Architectural Review Board Agenda
4:00 PM Thursday, January 9, 2025
Sussex Civic Center – Committee Room Second Floor

MEMORANDUM

TO: Architectural Review Board
FROM: Gabriel Gilbertson, Community Development Director
RE: January 9, 2025 Architectural Review Board
DATE: Monday, January 6, 2025

BUBBLES SUSSEX

SITE LIGHTING PHOTOMETRIC PLAN

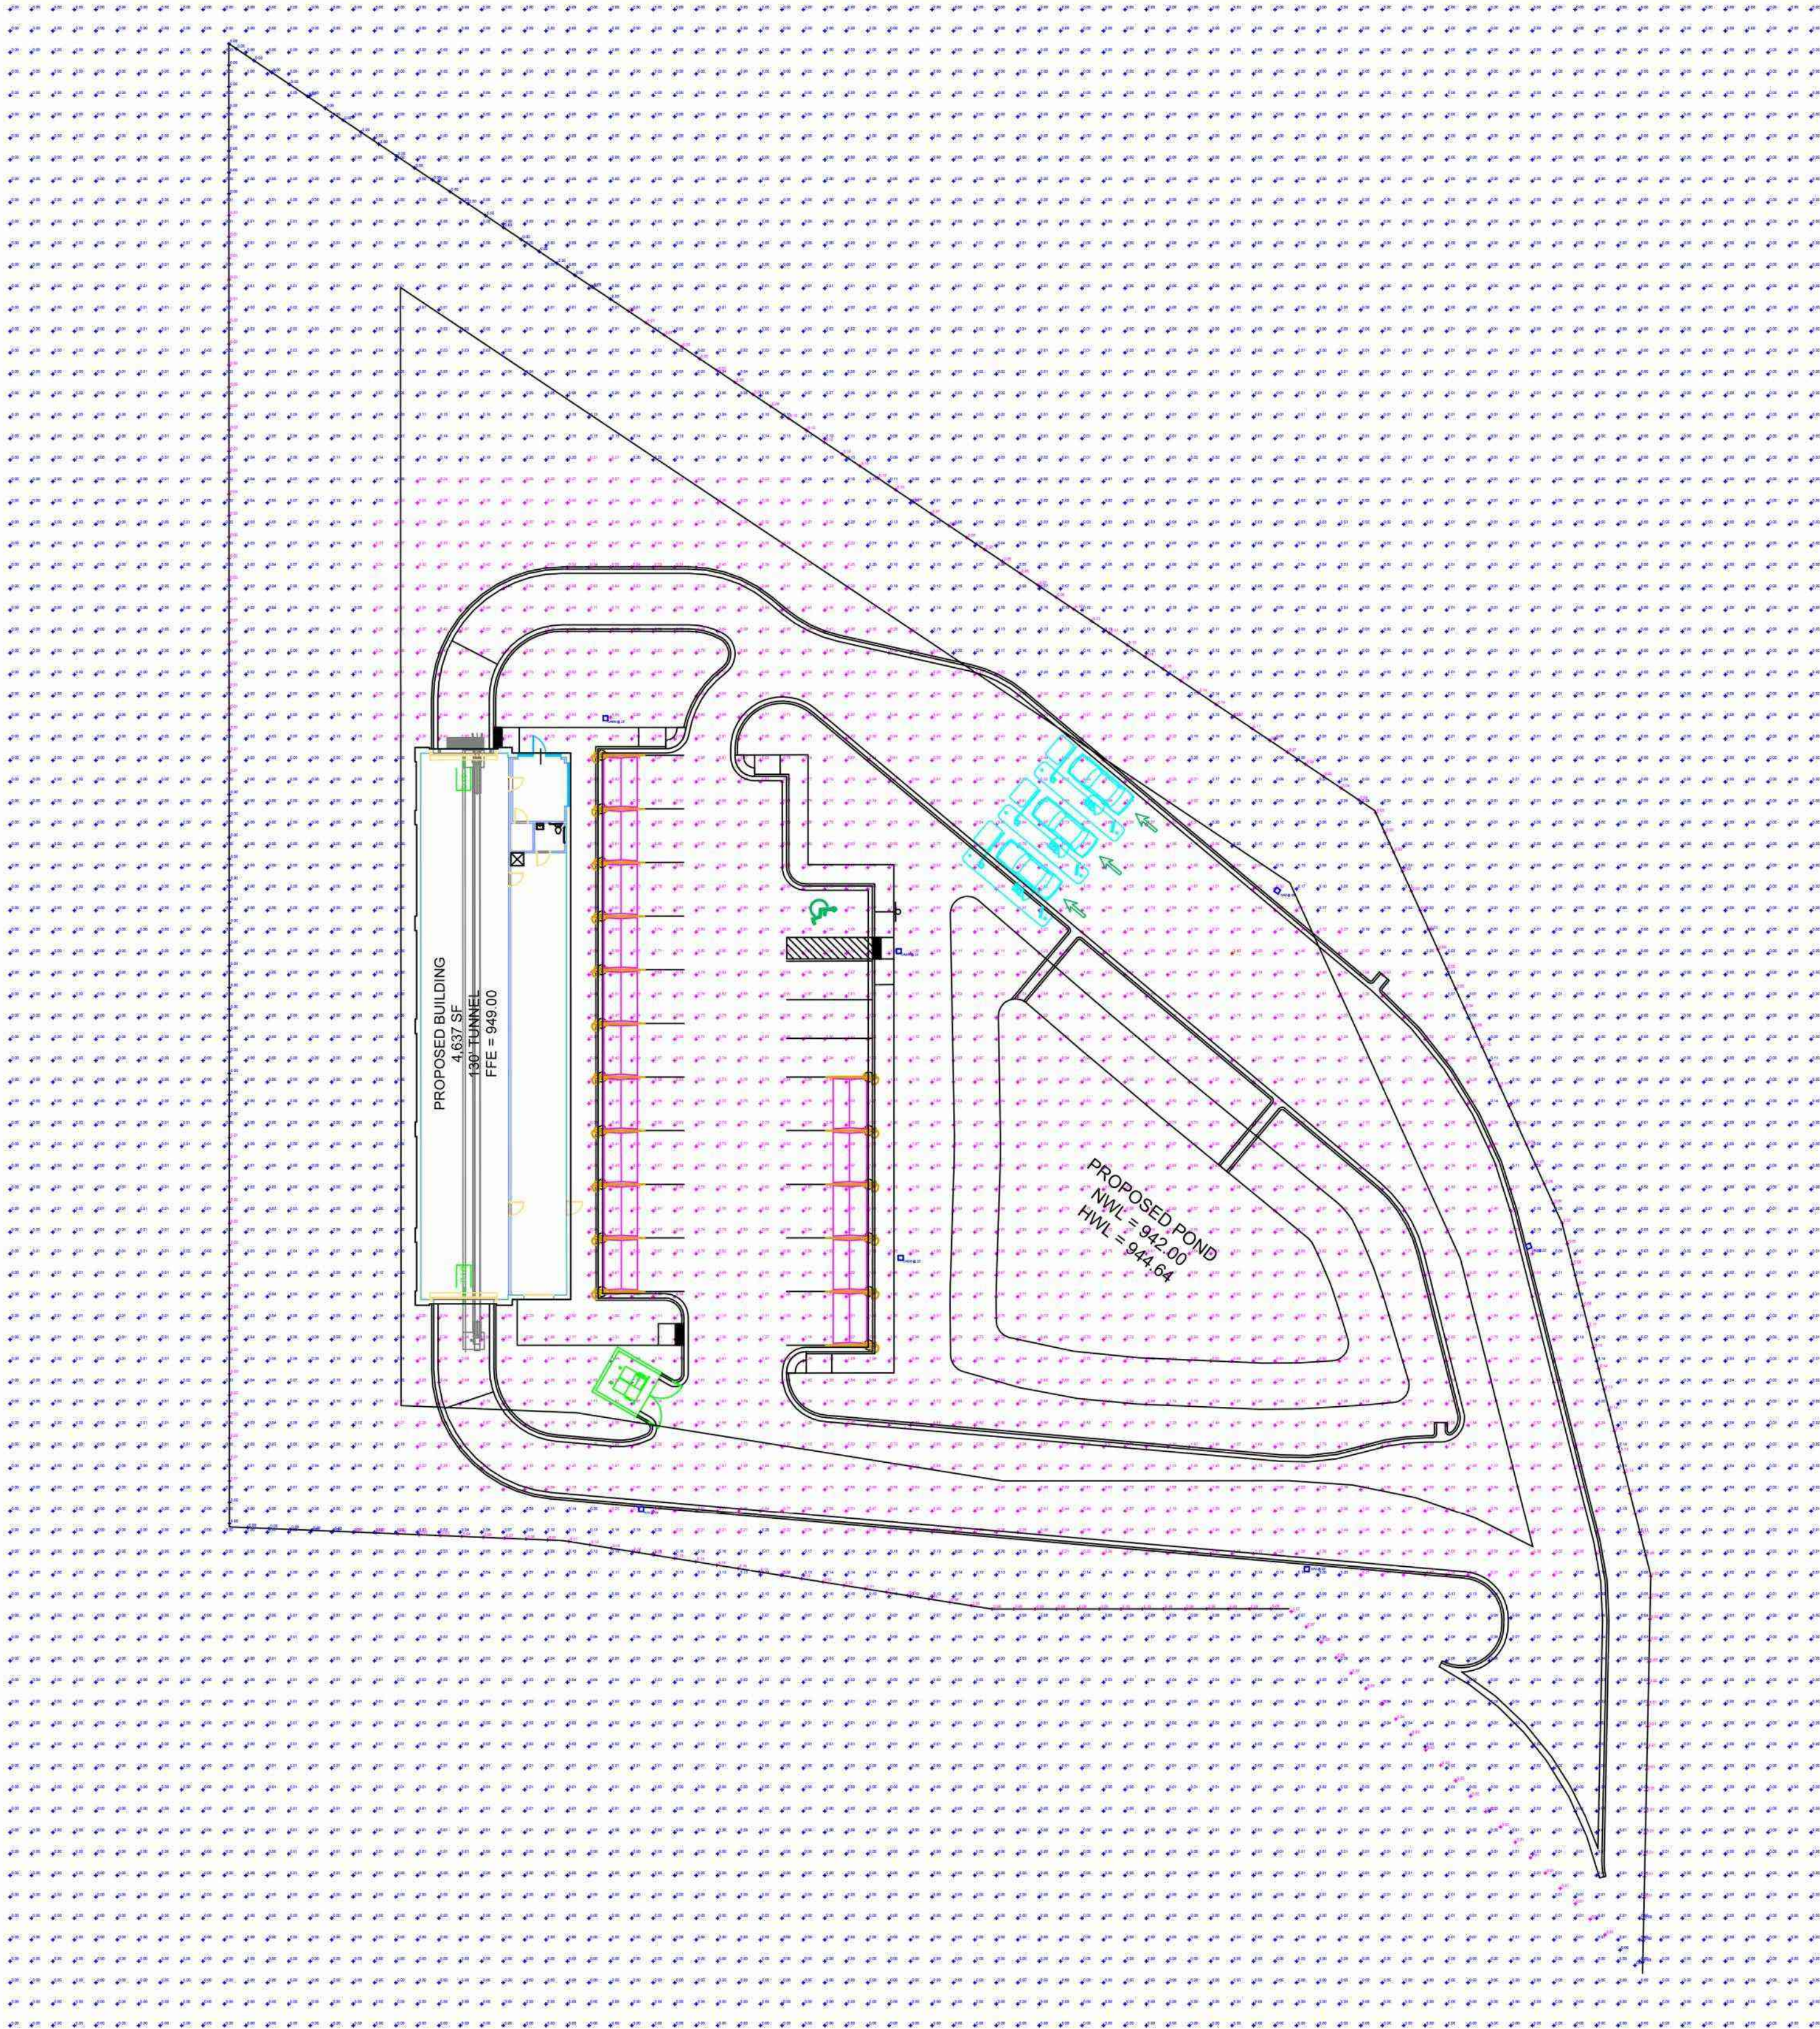
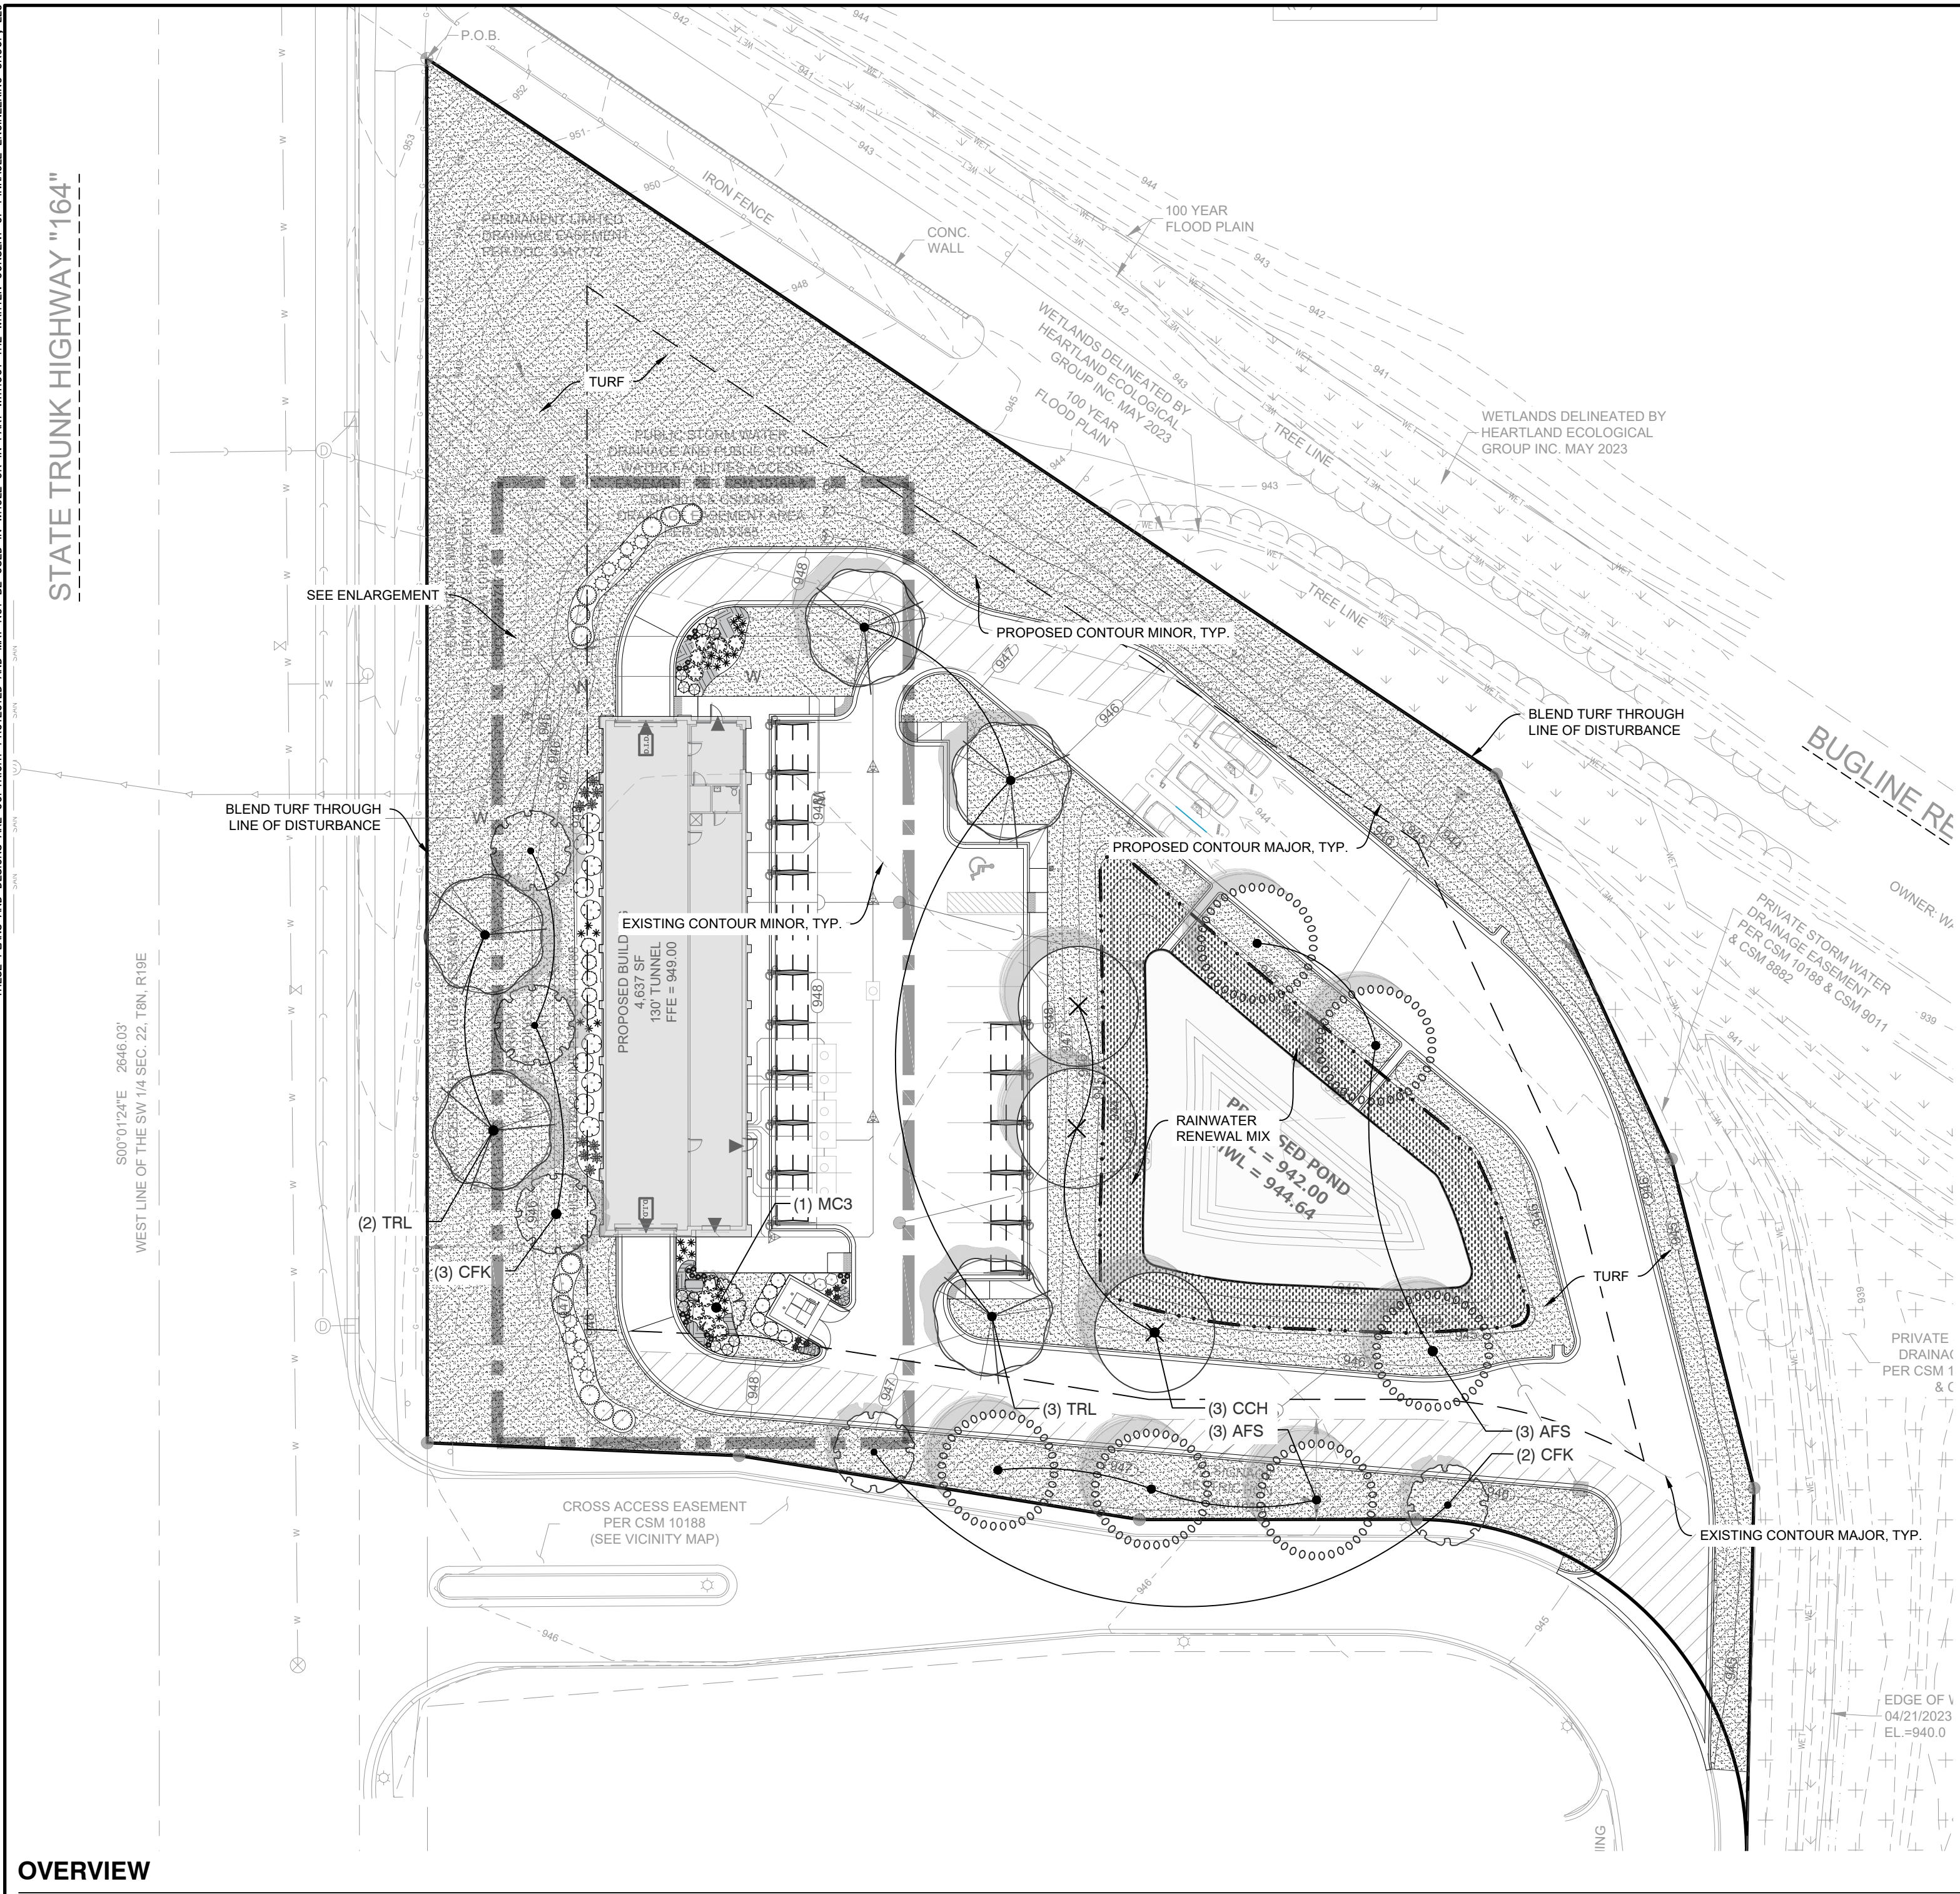
- The submitted lighting plan is very blurry and difficult to determine if there is light spilling on to adjacent properties. The details mention bases. If the poles are to have bases, they will need to be painted to match the building.

LANDSCAPE PLAN

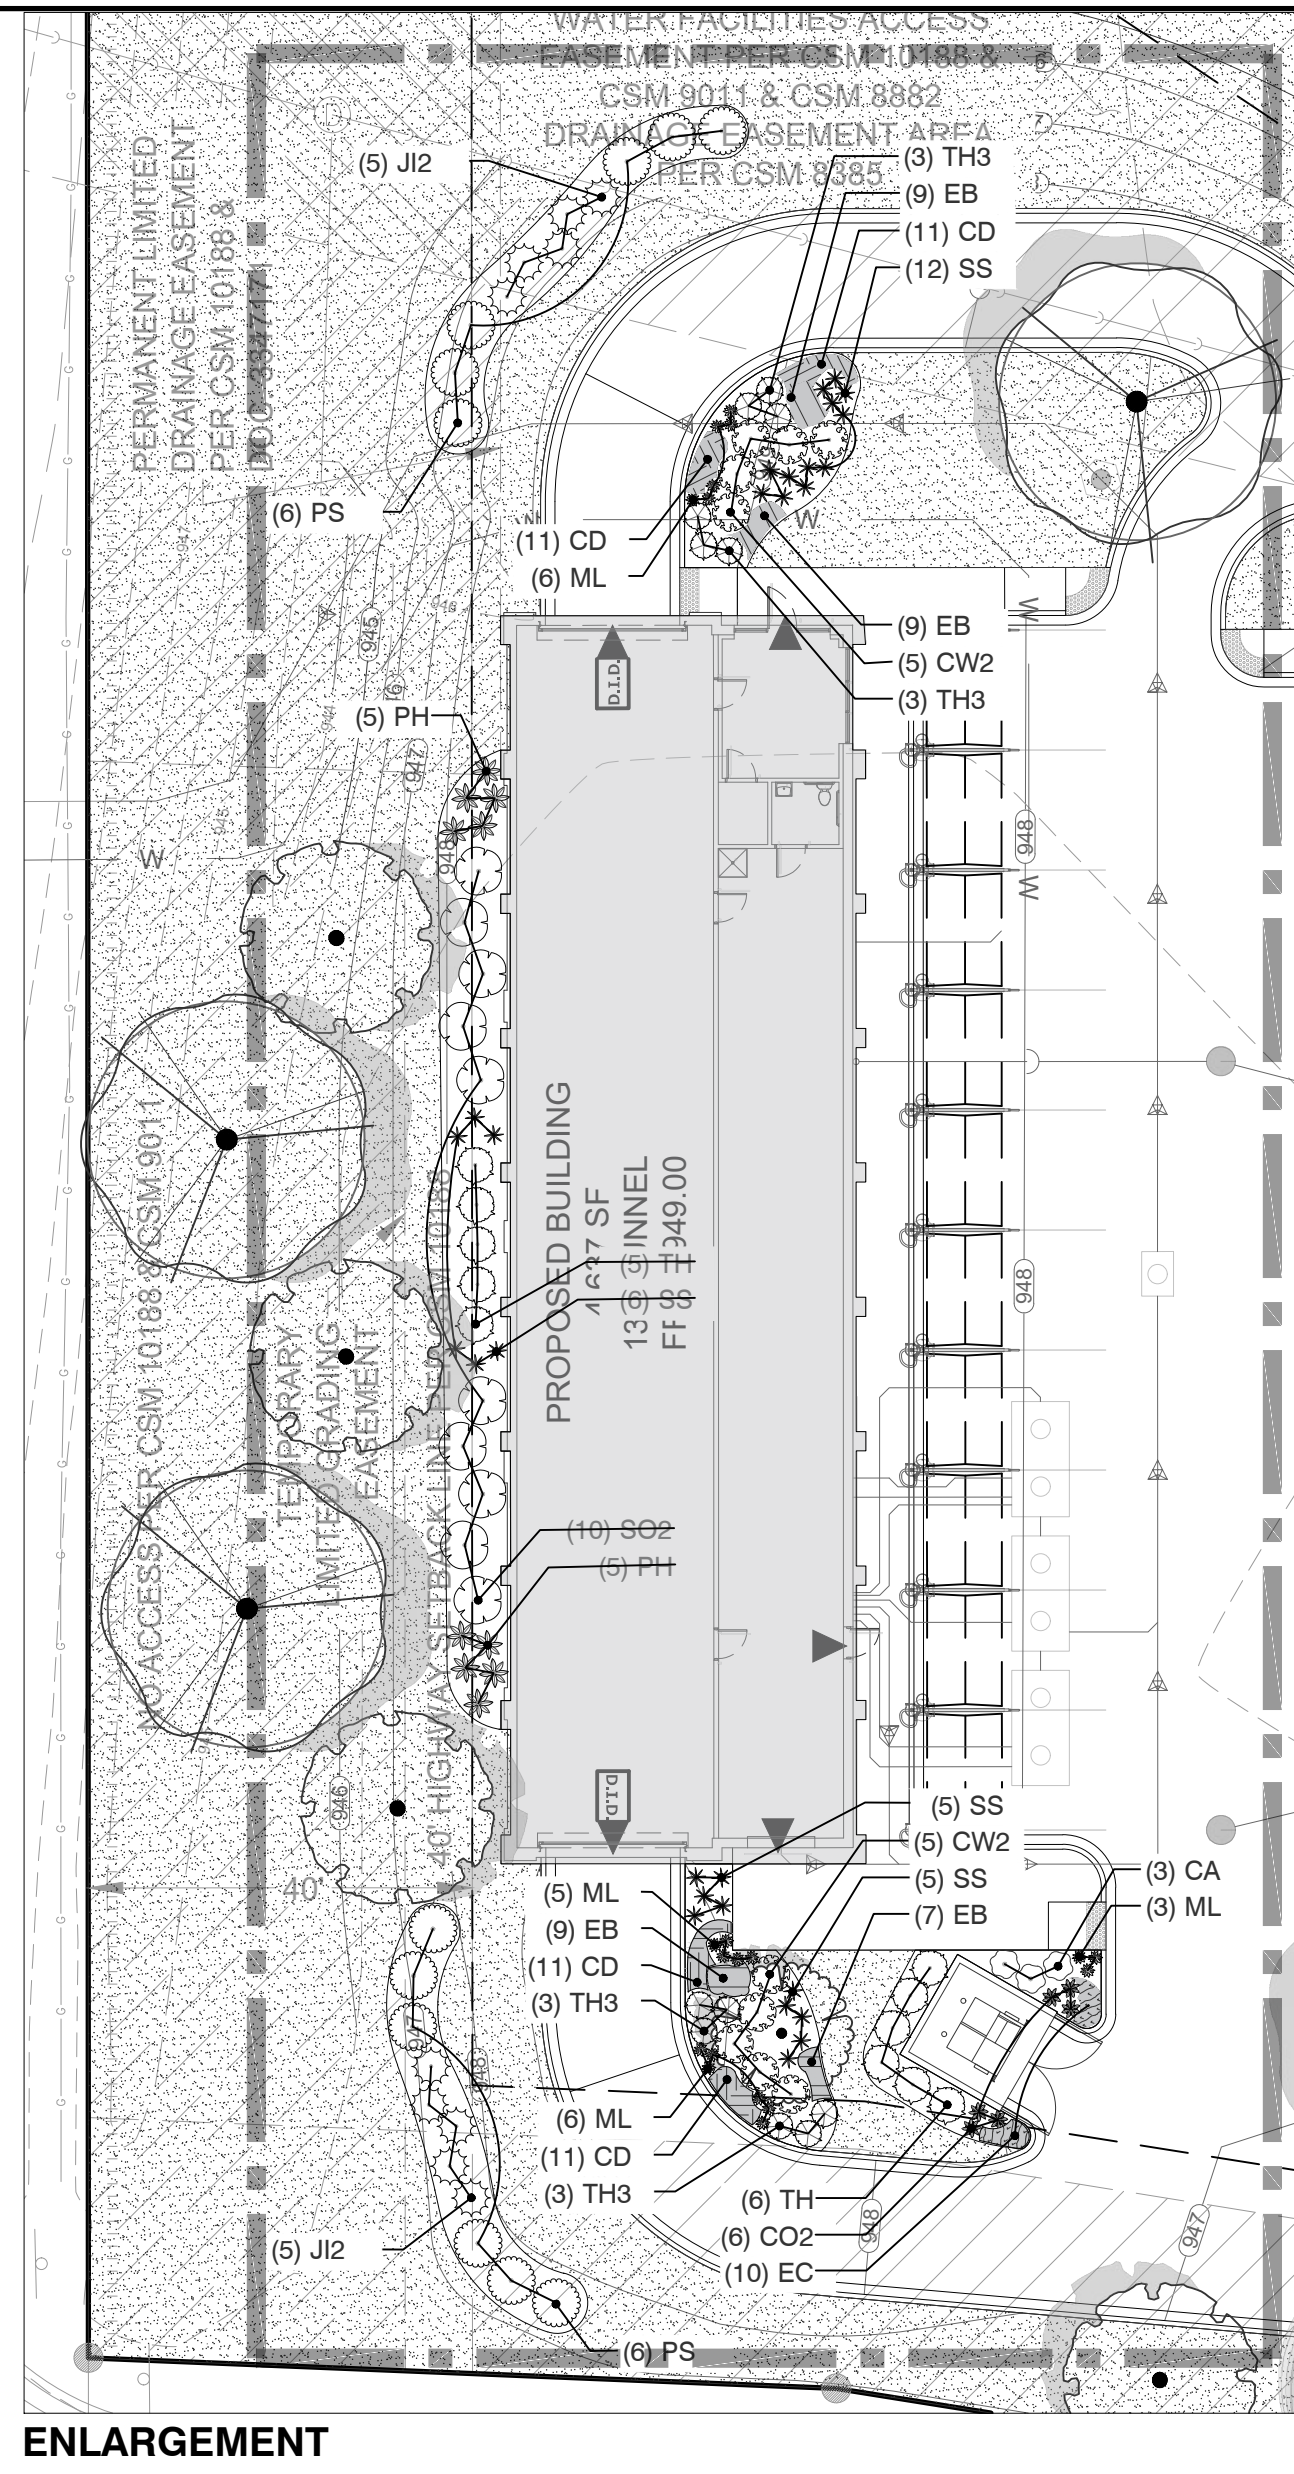
- Staff has requested the applicant to include planting counts on the landscape plan to ensure it at a minimum meets the previously approved number of 15 trees, 132 shrubs/grasses, and 88 perennial flowers. The site needs additional evergreen trees in the northern corner to provide additional screening from the multifamily development to the north and to bring the site in closer to the required number of trees as part of the landscape buffer requirements and as required by the previous approval of the site.
